PROPOSED TOWNSHIP DEVELOPMENT ON ERF 2642 AND PORTION 14 OF FARM 48, OPWAG, !KHEIS LOCAL MUNICIPALITY

APPLICANT: !Kheis Local Municipality

COMMENT AND RESPONSE REPORT

(DENC Ref. No: NC/EIA/11/ZFM/!KHE/OPW1/2020)

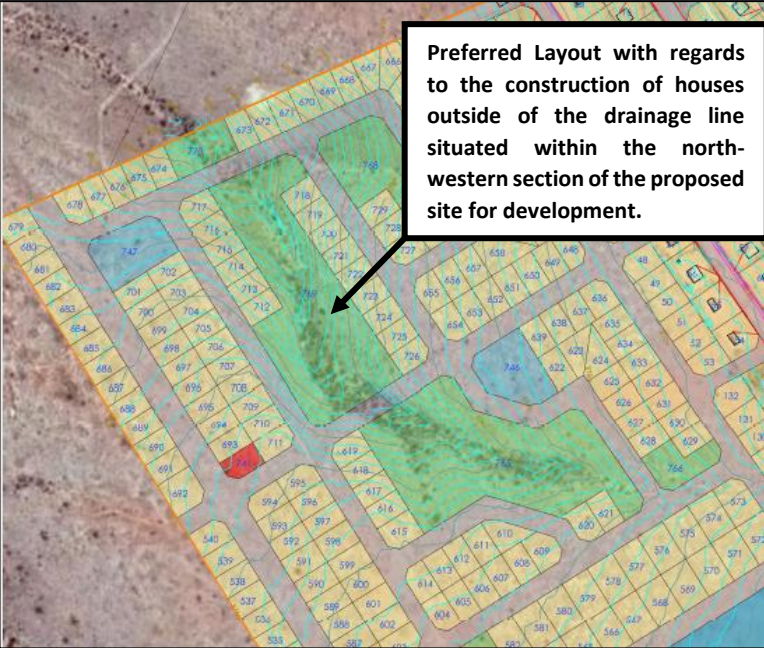
No.	Comment Date, Comment Format, Organisation/I&AP	Comment	Response from EAP/Applicant/Specialist/Project Manager <i>Please note: All registered I&APs will be given the opportunity to comment on the draft EIR.</i>
		<p>Interested and Affected Individuals, from lot 586/and 1464 that from part of lot 1018, as part of the Boegoeberg Community, one of the closest lots to the new proposed Township.</p> <p>Kind regards Daniel and Maryna Heese</p>	
25		<p>Regarded members of the Municipality,</p> <p>Re. Toilets</p> <p>I would like to share some thoughts with you regarding the proposed new development.</p> <p>1. TOILETS. We live in a water-scarce country and the water-sources needed to have flush toilets is simply not sustainable in the long run. I have been involved with a KZN NGO in a deep rural area of South-Africa in the Umkhanyakude District. We also have severe water challenges. We in collaboration with Oxfam Australia experimented with alternatives to Flush toilets and Long-Drop Pit latrines. That was my first introduction in waterless technology. We tested two models, one a commercial self-contained unit from Enviro-loo (pictured below) that was costly and a combination of a urine-diversion seat with self-constructed chamber options. I am happy to share our limited experience with you, but highly recommend the far superior functioning model for thousands of people, that can be found with Durban Municipality (eThekweni Municipality). They had been busy with waterless sanitation technology for over 12 years. I have supplied links to websites that explain technically on various levels, the challenges faced with introduction, the success and the research done with various options. So I have pasted both the success and failures and the reason for the failures.</p> <p>2. I will attempt to explain in layman's terms the principle behind different sanitation systems.</p> <ul style="list-style-type: none"> • In pit latrines the urine and faeces are mixed and seepage into the groundwater a reality. Apart from its environmental danger, it is often times not accepted as an option and seen as an insult to a person's humanity. The aspiration of the average person is for a flush toilet as shown in some of the articles in the websites quoted. 	<p>Respondent: EAP</p> <p>Noted with thanks. Please refer to the Engineer's Services Report (Appendix 4B) for existing and future services (water supply, sewage management, solid waste management, roads, electricity supply, and stormwater management) as recommended by the Engineer for the proposed Opwag Housing Development.</p> <p>With regards to sewage management, houses in the existing Opwag Settlement currently consist of Pour Toilets with a Leach Pit. There is no sewer bulk infrastructure which is recommended by the Engineer's as per the Engineer's Services Report (Appendix 4B) as the total, expected sewer flow would be 365 000l/day. Proposed upgrades, as per the recommendations of the Engineer, include;</p>

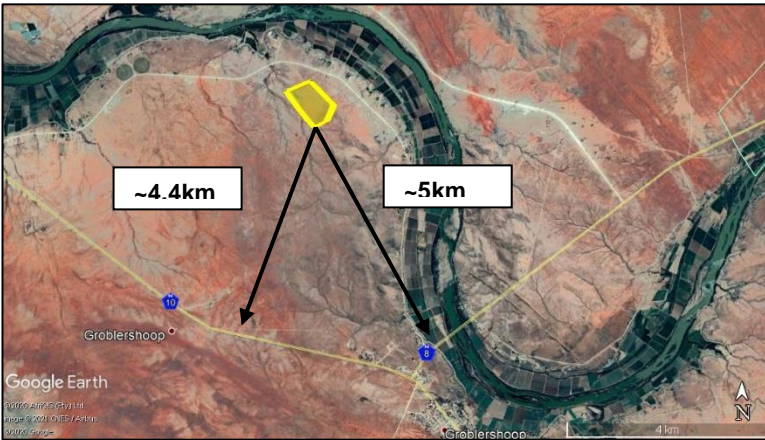
No.	Comment Date, Comment Format, Organisation/I&AP	Comment	Response from EAP/Applicant/Specialist/Project Manager <i>Please note: All registered I&APs will be given the opportunity to comment on the draft EIR.</i>
		<p>surface...a hard plastic sheet with holes at an angle, that allows the urine to seep through the holes into the bottom enclosed chamber, with a pipe that leads to a urine soak-away pit nearby. The faeces then dries out, needs to be raked to the back of the box from time to time and then the hard dry faeces needs to be collected after a year or more to be disposed of. The challenge with this system is that the holes can block and the angle is not steep enough for the faeces to slide down. They remain wetter longer and there is an extraction fan at the top of the chimney to eliminate most smells.</p> <p>It needs a full sun site, additional power for the extraction fan and people living higher might still get a whiff from the extraction fans, but the biggest deterrent is possibly the cost, it is more expensive. It is the best application for schools and community halls as seen in the photo below. The two glass tops are for the urinals. It is a very good method of coping with the urine. The urine dries into crystals. https://www.greenloo.org/enviro-loo-urinal.php</p> <p>2. URINE SEPERATION TWO CHAMBER SYSTEM</p> <p>a. An attempt is made to separate urine from faeces before the faeces drops down the seat. It is important for the success and acceptance of the systems to buy white high quality urine separation pedestals/seats. As can be seen in the photo below the system can be incorporated into the bathroom. It is advised to incorporation of a urinal against the wall in the blue bathroom picture as well. The urine can be collected in the same container the seat urine is diverted to.</p> <p>b. Build a two chamber system. Faeces are collected in one chamber until it is full, the seat is then removed and placed over the new empty chamber. The seal of the empty chamber is placed over the full chamber. The full chamber is left like it is until the second chamber is almost full. By now the faeces should be dried out. The dried out faeces is accessed through the sealed back wall and either disposed of or ground up and used as fertilizer in agricultural applications. The municipality can collect and dispose of the dried faeces.</p>

No.	Comment Date, Comment Format, Organisation/I&AP	Comment	Response from EAP/Applicant/Specialist/Project Manager <i>Please note: All registered I&APs will be given the opportunity to comment on the draft EIR.</i>
		<p>c. The selection of the site: It is vital for the optimal drying of the faeces that the back wall of the bathroom unit face North. To increase the absorption of the sun rays the back panel and the chimney should be painted black or be manufactured from hard black plastic. Place a mosquito net above the chimney. The bigger the chimney the greater the up draft and reduced smell.</p> <p>d. The urine can be diverted to a soak away, or a solar evaporation site similar to the environ system or utilized in a diluted form in agriculture. It is important to be aware of the hesitance of local communities to use human waste in any form as part of a greater agricultural system and extensive community awareness activities should accompany such use.</p> <p>e. By placing a bucket of sand, ash or sawdust next to the toilet with a little scoop, visual unpleasantness and smell will be further reduced. In addition, the material like ash or sand can accelerate the drying time.</p> <p>f. Should flies find their way into the system, they would try to get out and the only light will be at the top of the chimney that is sealed with a mosquito net. The flies will then fly up and down the chimney until they die. It is highly unlikely if the seat remains closed.</p> <p>In the image above the toilet stool is a porcelain seat, that can also stand on its own, going straight downward without the u-trap of standard toilet seats. To the right on the photo is a urinal, for the use of men, with an outlet that joins the urine caught with the separate division in the seat. This photo was sourced from</p> <p>https://en.wikipedia.org/wiki/Urine-diverting_dry_toilet an example from Peru.</p> <p>This is what a urine separation seat can look like. The front chamber catches the urine and the dark blue is where the faeces drops down into the chamber. In this photograph there is a division that is not there. It is a pipe that have straight sides.</p> <p>This is local, South-African manufactured urinals on the market. It is advisable that the pipes should take the shortest route out, but protected from sun and damage.</p>
